**Subject: Modera Raleigh (PA2020-0037)**

# PRE-APPLICATION CONFERENCE MEETING SUMMARY NOTES

Prepared for  
Modera Raleigh  
PA 2020-0037 on October 7, 2020

## PRE-APPLICATION CONFERENCE MEETING SUMMARY

SHEET NO.  
**ST09**  
JOB NO.  
BVN-24

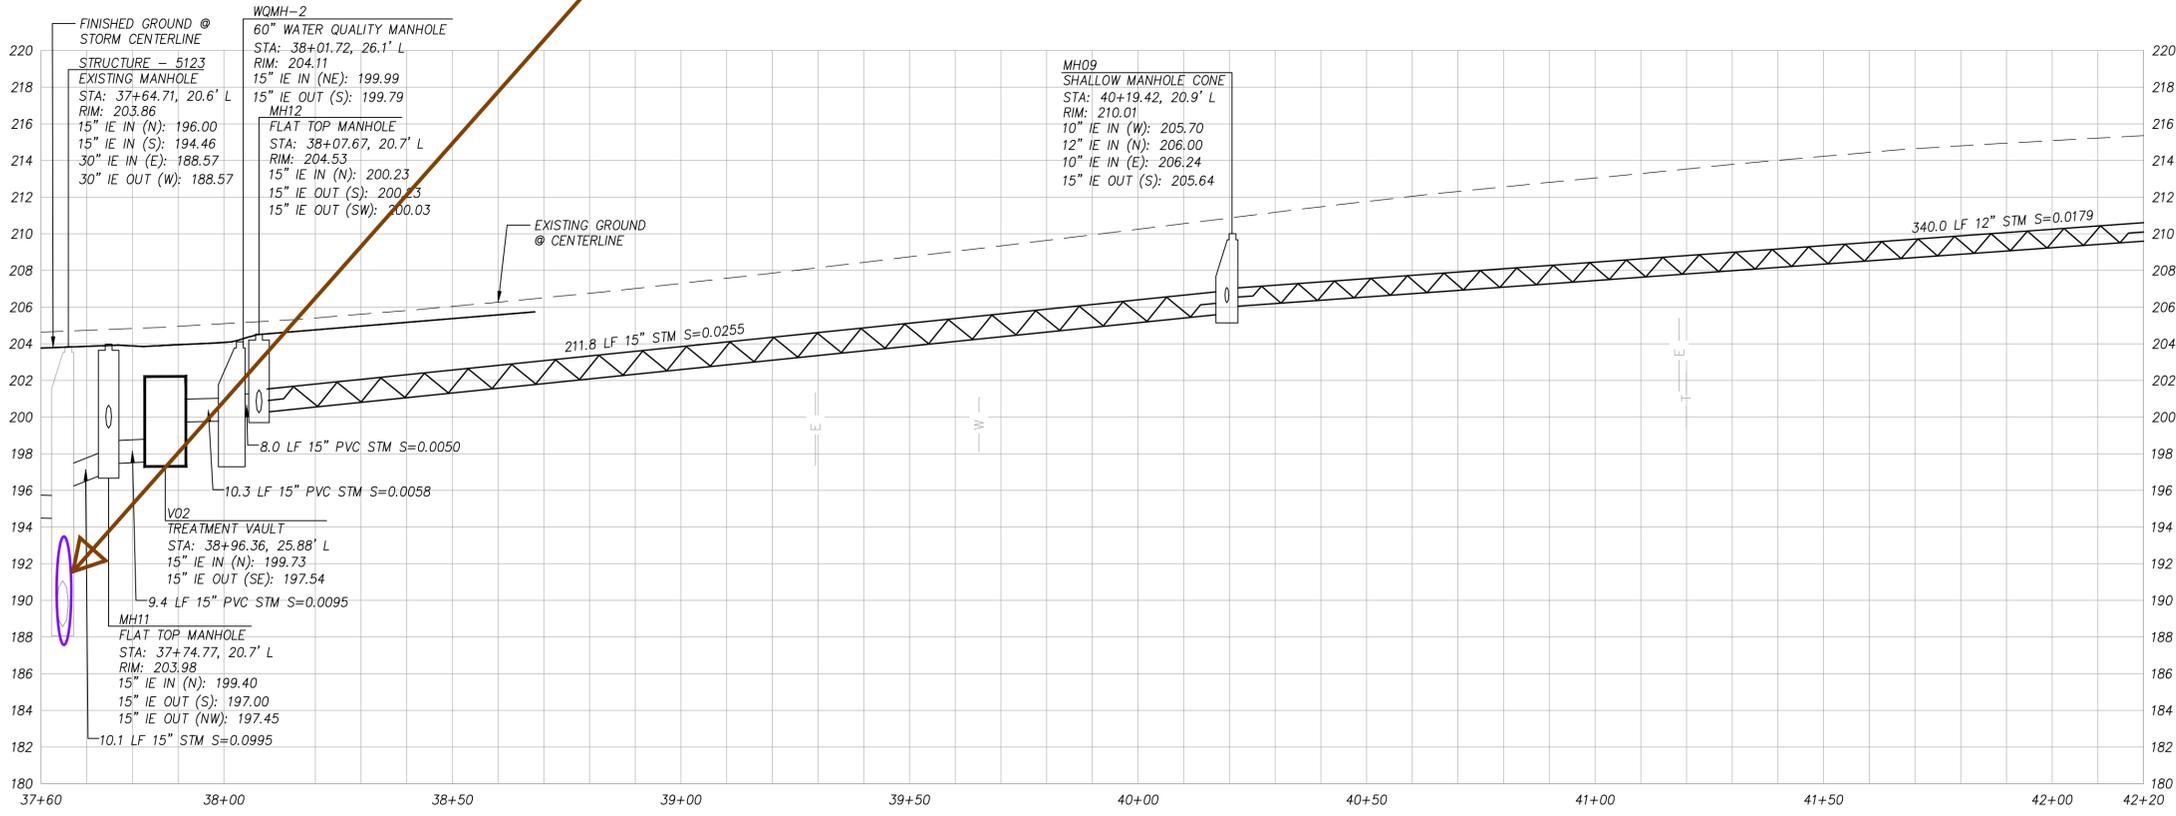
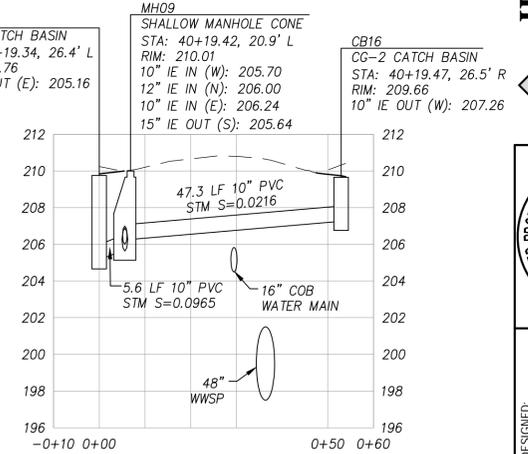
**Plan B (not preferred):** Replace approximated 104 feet of 48-inch reinforced concrete pipe with 60-inch concrete pipe. Will allow for replacement of the upstream and downstream sections of the pipe with property redevelopment. Match Invert - new top of pipe ~193.2 feet
